**SUBJECT: RESPONSE TO DISAPPROVAL, TA-63 TRANSURANIC WASTE FACILITY
PERMIT MODIFICATION REQUEST, REVISION 1.0, LOS ALAMOS
NATIONAL LABORATORY, EPA ID #NM 0890010515, LANL-11-045**

**RESPONSE TO NOTICE OF DISAPPROVAL
TA-63 TRANSURANIC WASTE FACILITY
PERMIT MODIFICATION REQUEST, Rev. 1
LOS ALAMOS NATIONAL LABORATORY**

**RESPONSE TO THE
DISAPPROVAL, TA-63 TRANSURANIC WASTE FACILITY
PERMIT MODIFICATION REQUEST
REVISION 1.0
LOS ALAMOS NATIONAL LABORATORY
EPA ID# NM 0890010515
LANL-11-045**

Figure 2-5. Overall Site Plan

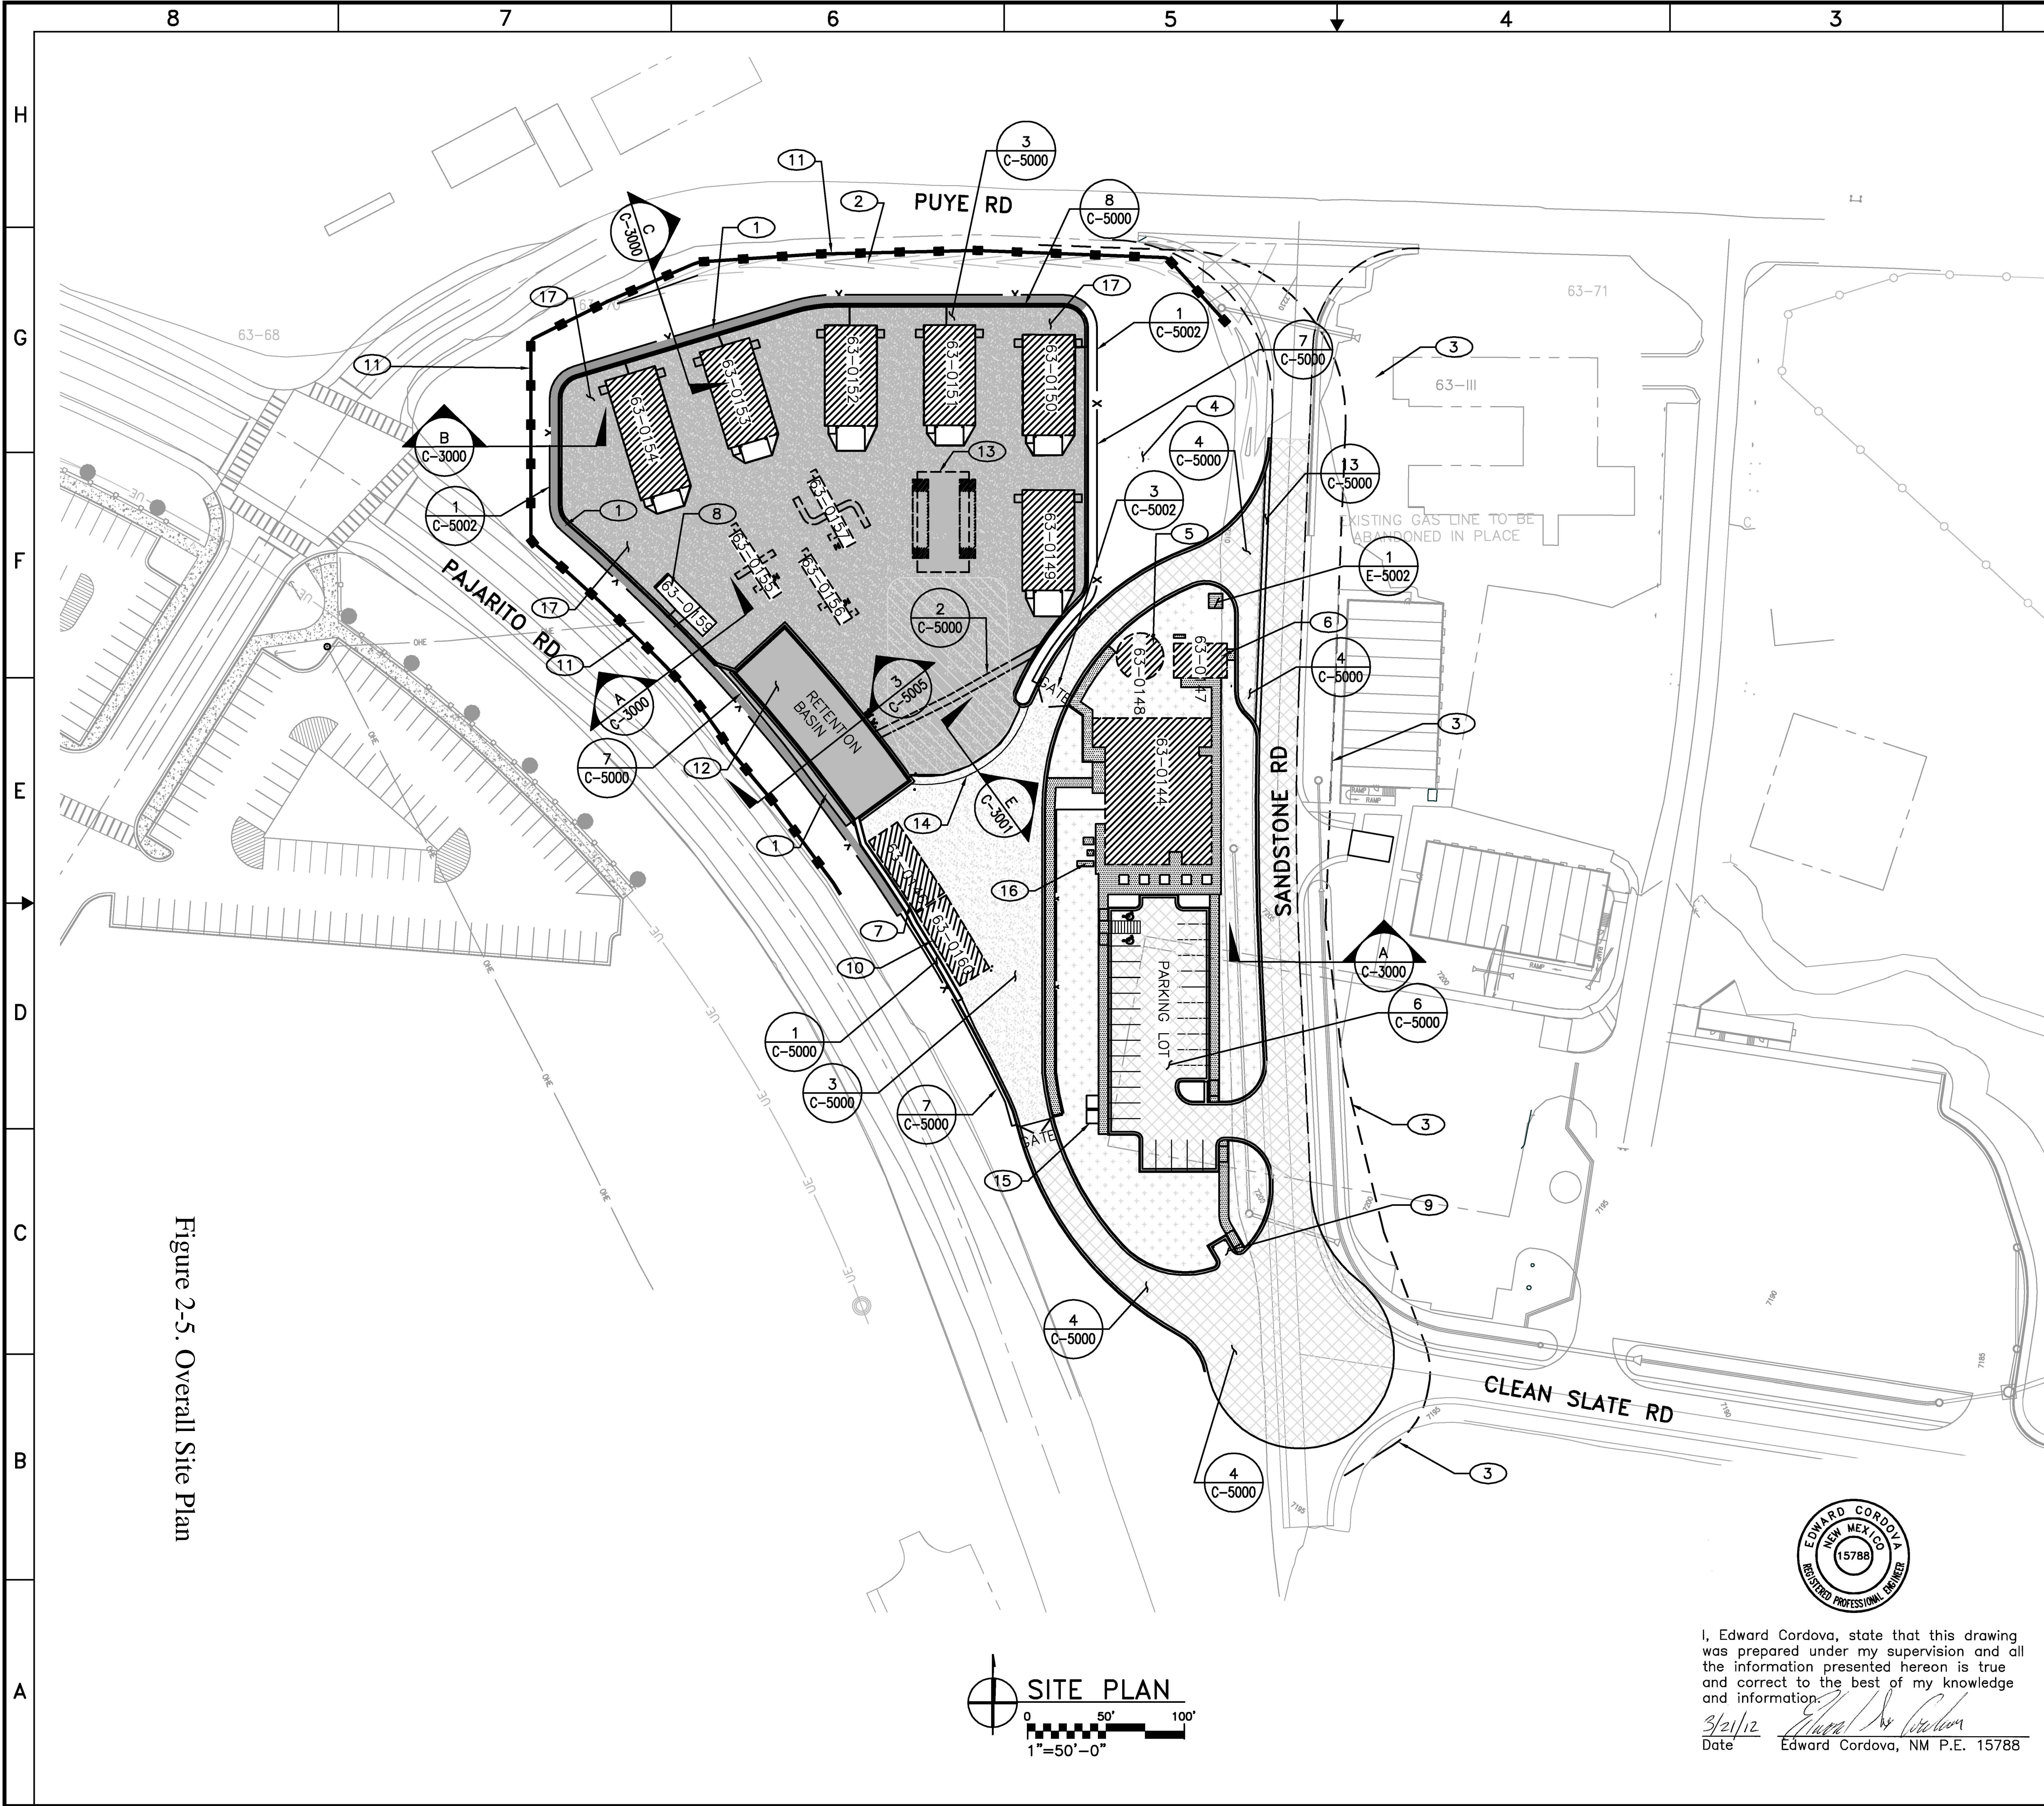
2. *Section 2.2 still states that Figure 2-5 depicts "the location of areas where storage will occur highlighted," but the figure in fact does not have the storage areas highlighted. Revise the section to remove that statement, and instead refer to Figure 55 in Attachment G, Proposed Revisions to the LANL Hazardous Waste Facility Permit, and/or Figure F-1 of Attachment F, TA-63 Transuranic Waste Facility Closure Plan.*

11. *Figure 2-5 indicates an "Area designated as future expansion," but there is no explanation of what this future expansion will be. Revise the PMR to discuss what type of future expansion (e.g., additional characterization trailers) the Permittees propose in Figure 2-5.*

Figure 2-5 has been revised to show the portions of the TWF where storage may occur and Section 2.2 has also been revised to reference Figure 55. The revised Figure 2-5 is included as Attachment C of this submittal.

Section 2.2.4 of the PMR has been revised by adding the following phrase to the description of additional characterization trailers to reference Figure 2-5: "Additional trailers may be needed as characterization needs for the facility change and would be located in the area noted (Note #13) for future expansion in Figure 2-5, Overall Site Plan".

Figure 4-2
Transuranic Waste Facility:
Soil Vapor Monitoring
Network

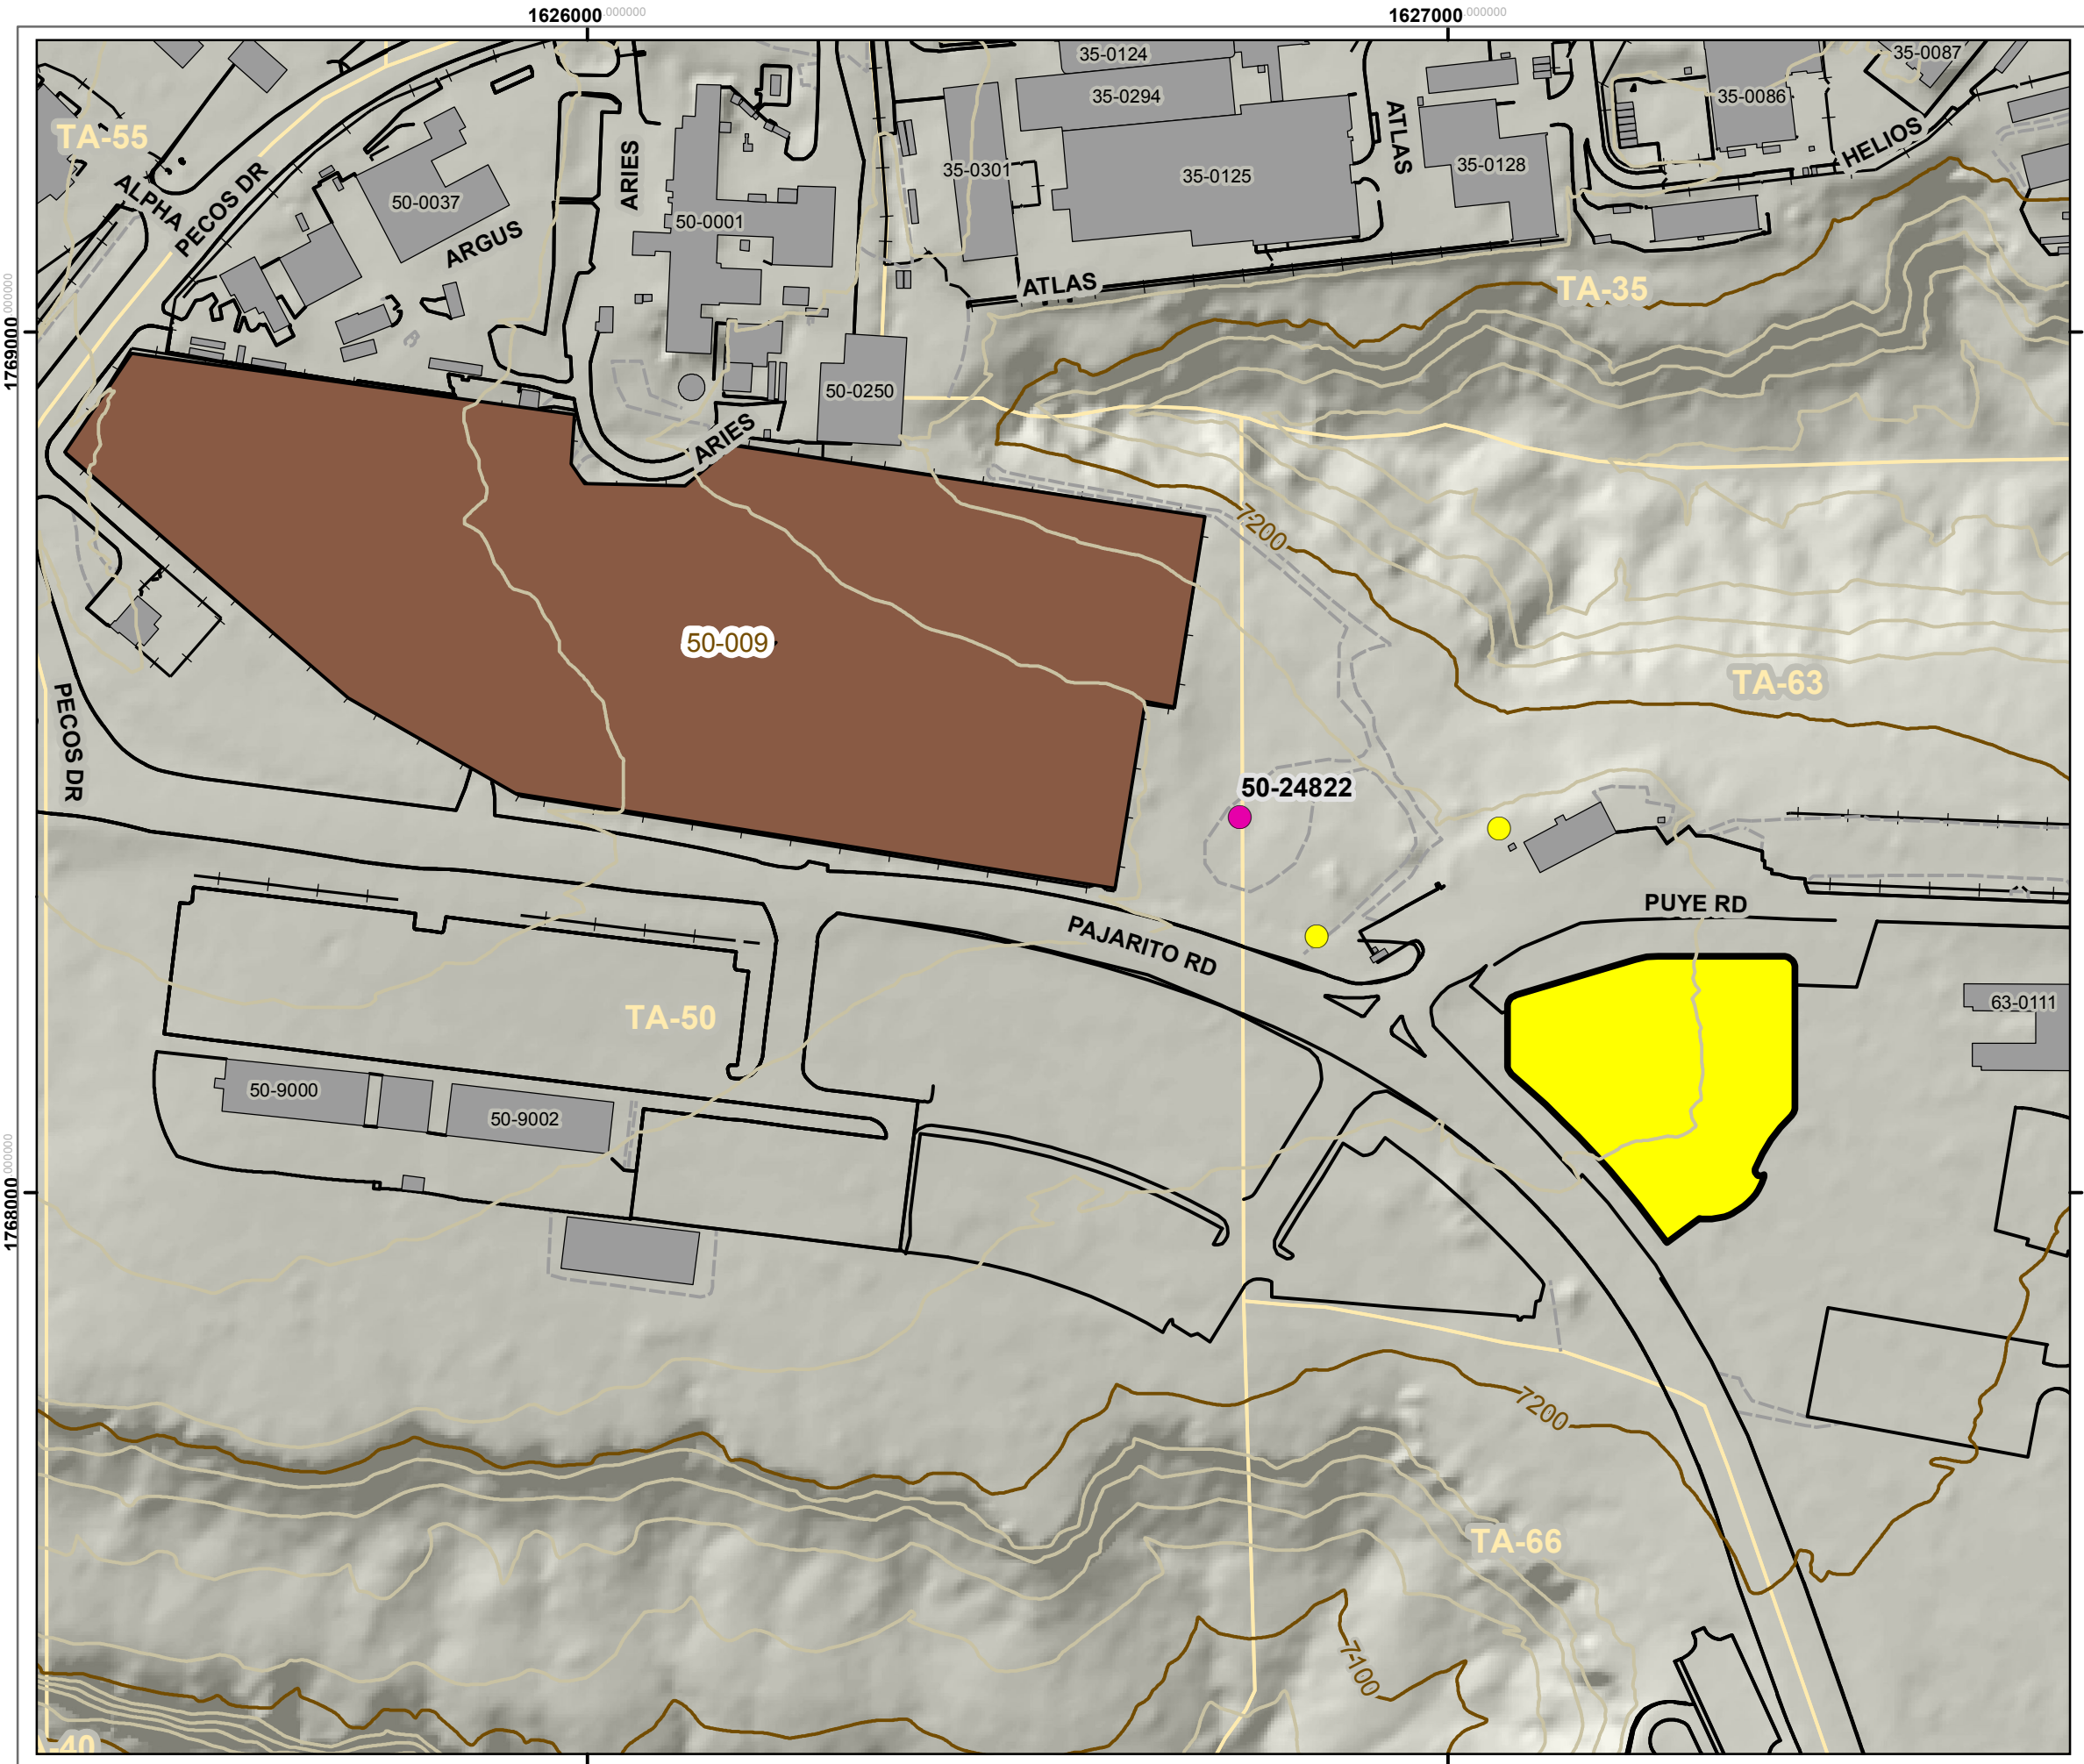
The Permittees request that a meeting be arranged with the NMED-HWB to further discuss the soil vapor monitoring network proposed in the Response to Comment 30. Some information regarding the proposed goals for the monitoring network was previously discussed in a meeting with NMED-HWB on May 31, 2012. Additional questions indicated in the response have been raised as the proposal was developed. A meeting would also allow further explanation of the proposal, clarify any unresolved technical details, and potentially help to answer any further questions by your office.

The proposed locations for the two monitoring wells are included in Figure 4.2 in Attachment E of this NOD Response. These new wells will be situated in the area north of Puye Road in order to place them between the central source in the MDA-C vapor plume and the nearest boundaries of the TWF. These locations will provide monitoring data inline with the source of the vapor plume and potential receptor sites at the TWF. As directed in NMED's December 8, 2011 approval for the Phase III Investigation Report for MDA-C (HWB-LANL-11-050), LANL is currently monitoring the 25-ft and 142-ft ports in existing vapor monitoring well 50-24822 on a semi-annual basis. Data from these monitoring ports, which are located between the MDA-C vapor plume and the new monitoring wells, will be used along with data from the new wells to evaluate potential exposure pathways. The existing well is described in the Phase III Report.

The proposed soil vapor monitoring wells will sample vapor from the 25 ft and 60 ft. levels. The 25 foot level is proposed as a near surface layer sampling point considering the potential for at least a 15 foot variance in the surface elevation of the TWF site at construction and during preliminary grading. The 60 foot depth is chosen to provide an additional sample below the surface depth. As shown in Figure 5.1-1 of the March 2011, Completion Report for Regional Aquifer Well R-60, (LANL, EP2011-0003), the surface tuff layer (Qbt3, Unit 3 of the Tshirege Member) extends to a depth of 100 feet so there is
